**TOWN OF MORIAH
ESSEX COUNTY, N.Y.
WATER & SEWER MAIN REPLACEMENT – PHASE II**

Addendum No. 1 – April 22, 2021

CATCH BASIN REPLACEMENT DETAIL

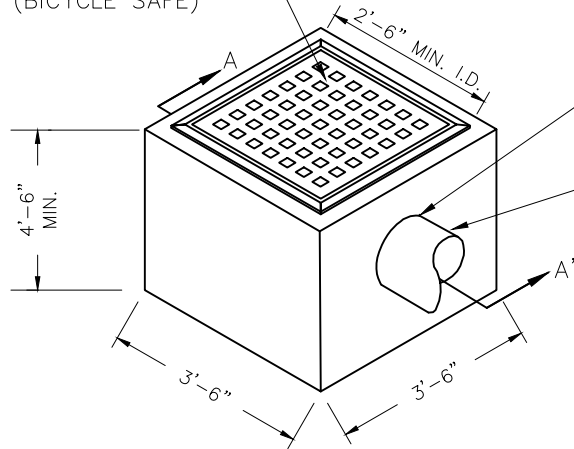
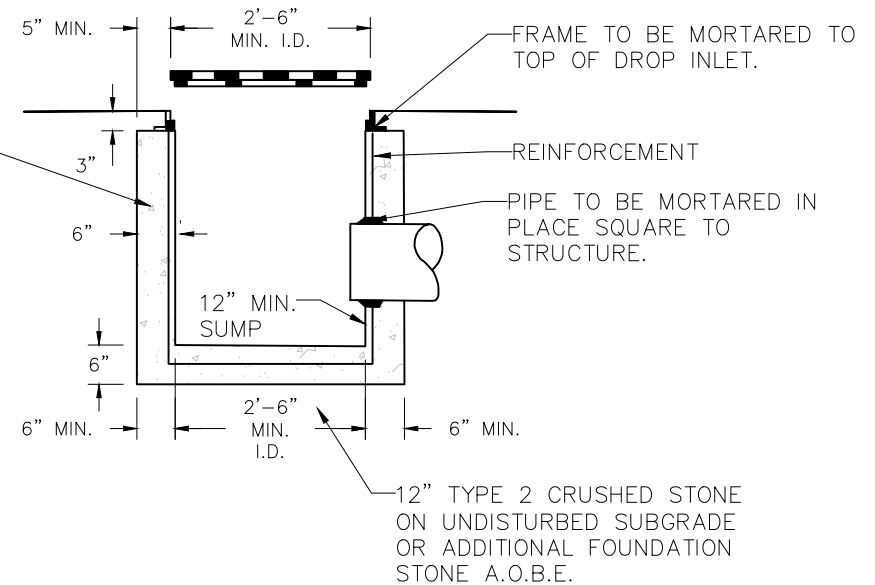
- a. Bid concrete sidewalk using 6 x 6 W2.9 x W2.9 welded wire fabric as shown on detail.
- 7. Drawing Sheet C-11 – Add New Catch Basin Detail:**
 - a. Add new catch basin detail to drawing sheet C-11 as included in **Attachment 3**.
